IRAQI CIVIL DEFENSE  
HEADQUARTERS  
BAGHDAD, IRAQ

**SIGIR PA-06-090**  
**APRIL 26, 2007**

SUBJECT: Report on Iraqi Civil Defense Headquarters, Baghdad, Iraq (Report Number  
SIGIR PA-06-090)

**Figure 7. Contractor as-built drawing for ICD HQ building A bathroom**

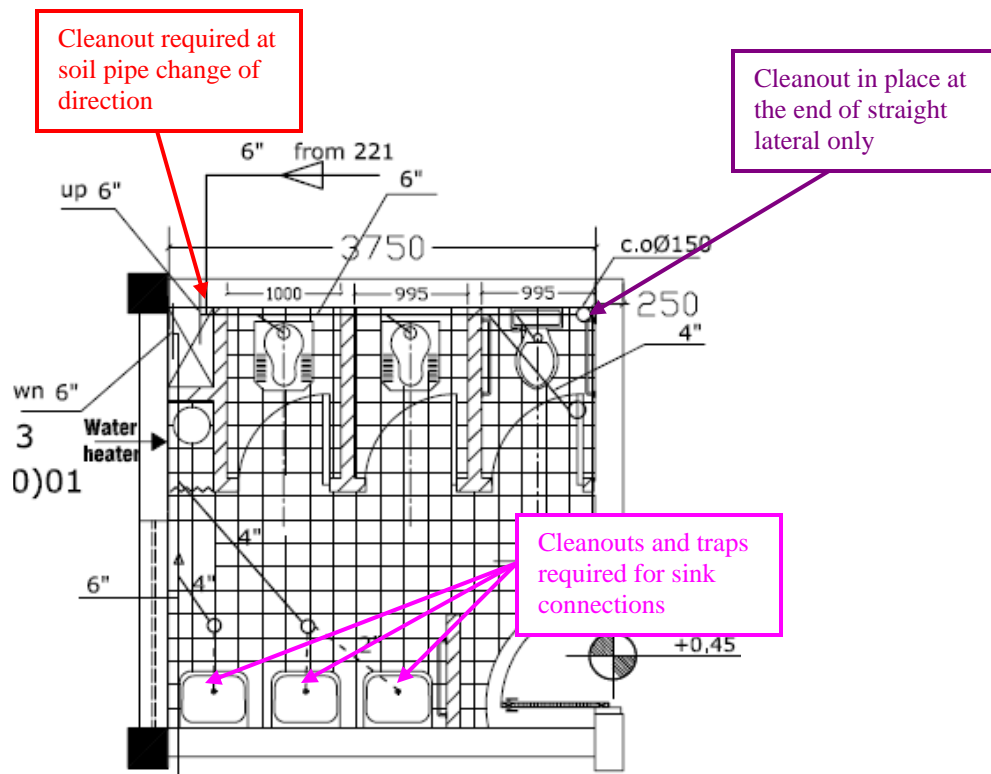
The as-built drawings for the ICD HQ bathrooms indicate cleanouts were only used at the far end of a straight run of soil pipe, not for every toilet trap and change of direction (Figure 7). Since the 30% and 60% design drawings were unavailable for our review, we cannot determine whether the government engineers reviewing the bathroom design drawings failed to detect and identify the lack of sufficient number of cleanouts and traps at the correct locations. However, the government design reviews do not mention the absence of cleanouts and traps at the correct locations as a deficiency.

Figure 13. Contractor as-built drawing of the third floor light fixtures

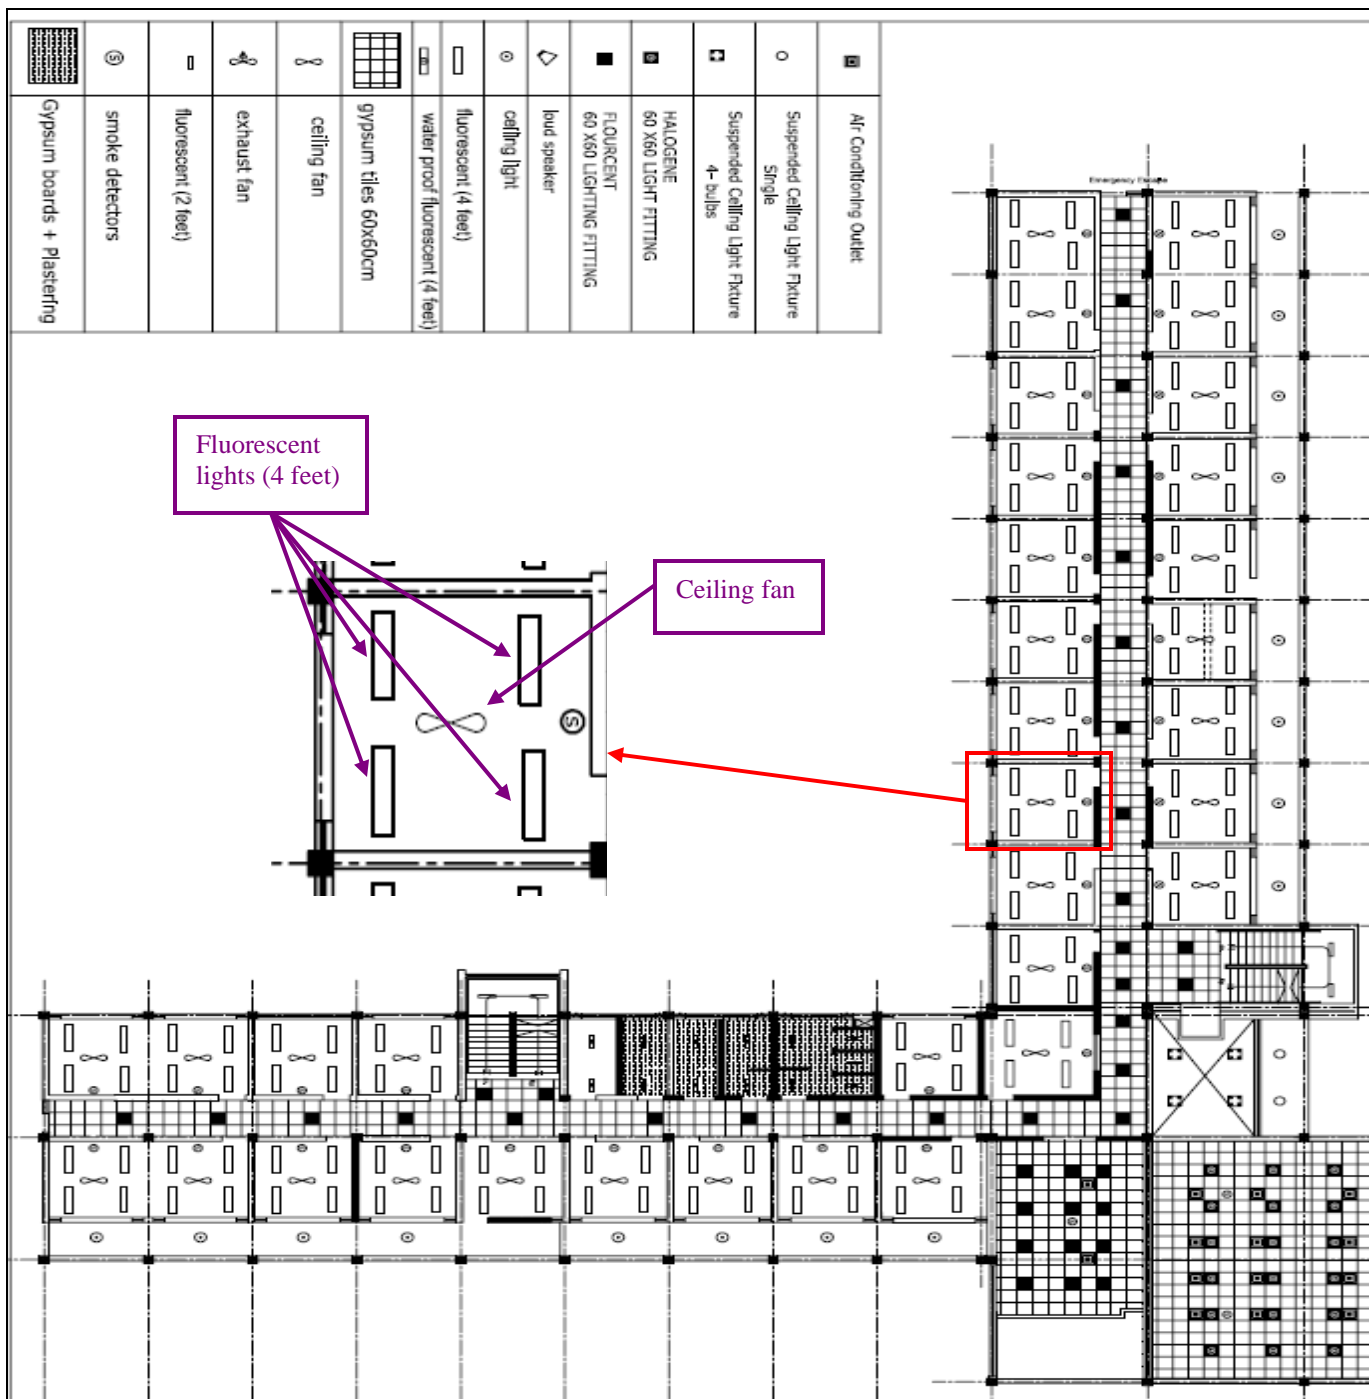
The as-built drawings do not include any electrical drawings; specifically, there are no electrical line drawings and branch circuit distribution plans. Without this information, the ICD HQ personnel will not know the size of the circuit load and breakers, type, quality, and gauge of wire, as well as load factor for distribution design. This information is critical for proper maintenance and repair of the electrical system.

**Figure 16. Contractor’s as-built drawing for expansion joint for ceiling and floor slab**

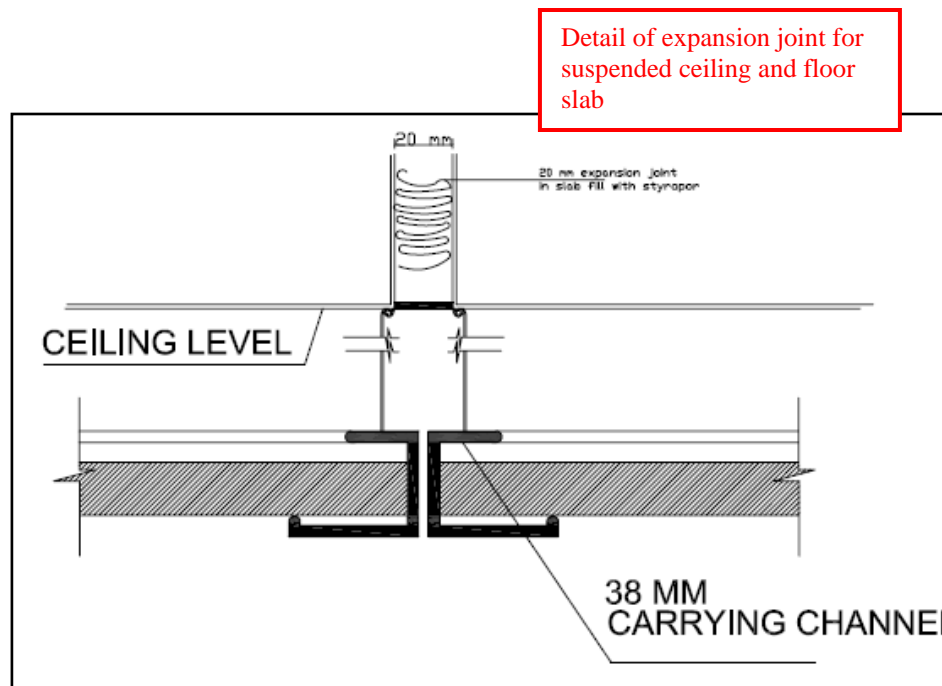
“complete” as-built drawings, no expansion joints were used on the floor, wall, or roof of the ICD HQ building. However, both GRD and ICD HQ personnel stated that at least one expansion joint was installed on the exterior wall of the ICD HQ building (Site Photo 58). The location of this expansion joint is questionable because it does not appear to be in the correct spot (Figure 18). Further, the installation of the expansion joint does not appear to be done correctly (Site Photo 59). The intent of an expansion joint is to allow a building to withstand thermal expansion and contraction and foundation movements; however, the fact that the subcontractor put plaster on top of the expansion joint negates its effectiveness.

We found no evidence of the installation of any type of expansion joint system at any location in this building.

**Figure 19. Sliding door fabrication detail (from as-built drawings)**

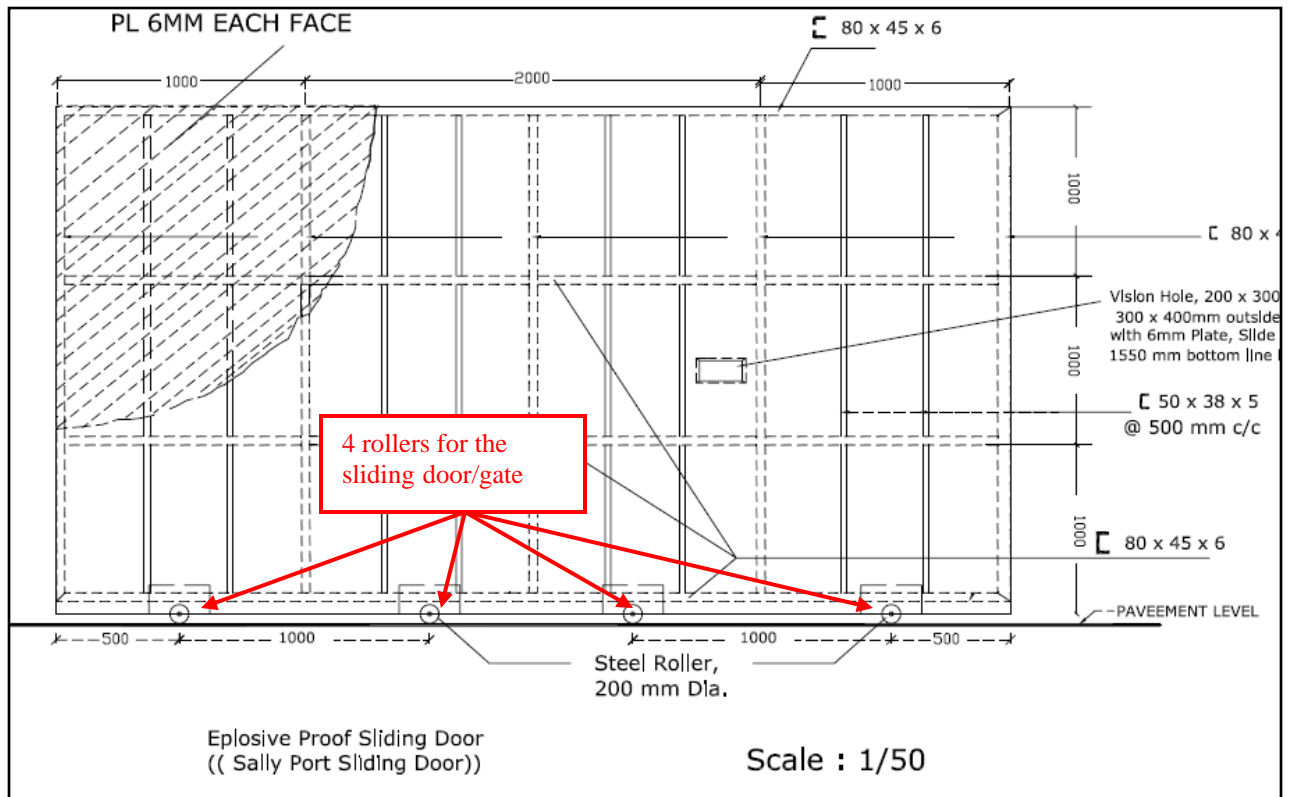
The as-built drawings for the Sally Port sliding gate indicate that each gate has four rollers/wheels and one vision hole (Figure 19). However, during our site visits, we identified that each gate had only two rollers/wheels and at least one gate had no vision hole (Site Photo 60). The lack of two additional rollers means the weight of the anti-explosive gate is distributed over two fewer wheels, resulting in additional stress on the two rollers. The vision hole is critical to enable the sliding gate guard to identify those attempting to enter the ICD HQ compound. Without a vision hole, the guard will have to partially open the sliding door in order to identify anyone approaching; this significantly increases the danger to the guard and the compound.

Figure 21. Contractor's as-built drawing (directional) for the sewer lines at the ICD HQ compound

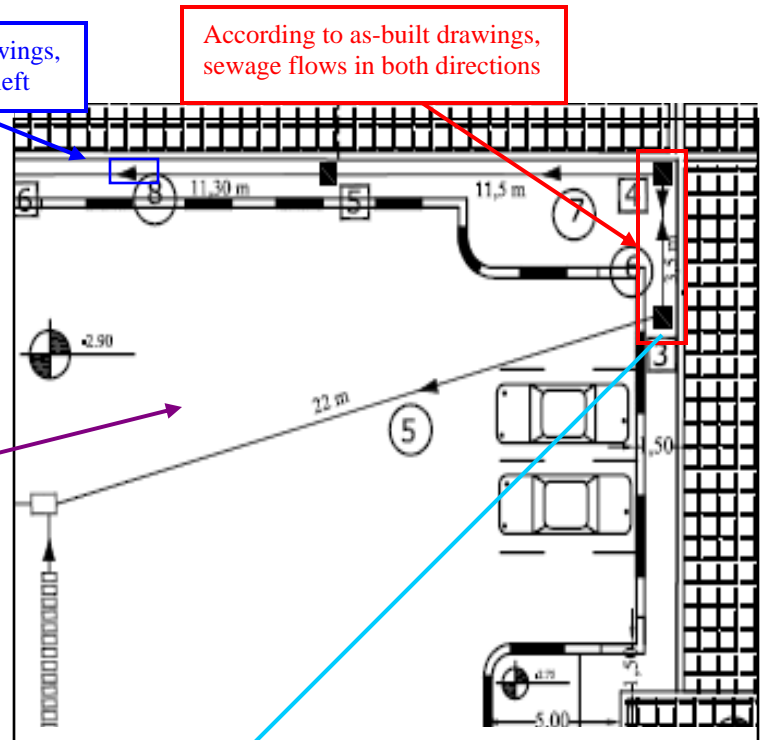
The sewage line site plan as-built drawings for the ICD HQ main building does not provide a correct sewage flow diagram (Figure 20). For example, in one instance sewage appears to flow in opposite directions (Figure 21), which is not possible considering the sewage lines run directionally by gravity. We lifted the manhole cover (Site Photos 61 and 62) and determined that the sewage actually flowed from Box 4 to Box 3. In another instance, the direction of the sewage flow is not correct. Figure 21 shows sewage directional flow running from Box 4 to the left toward Box 5; however, when we lifted the manhole cover, we determined the flow of the sewage line was running from Box 5 to the right to Box 4 and then downward to Box 3 (Figure 22 shows the correct directional flow of sewage lines).
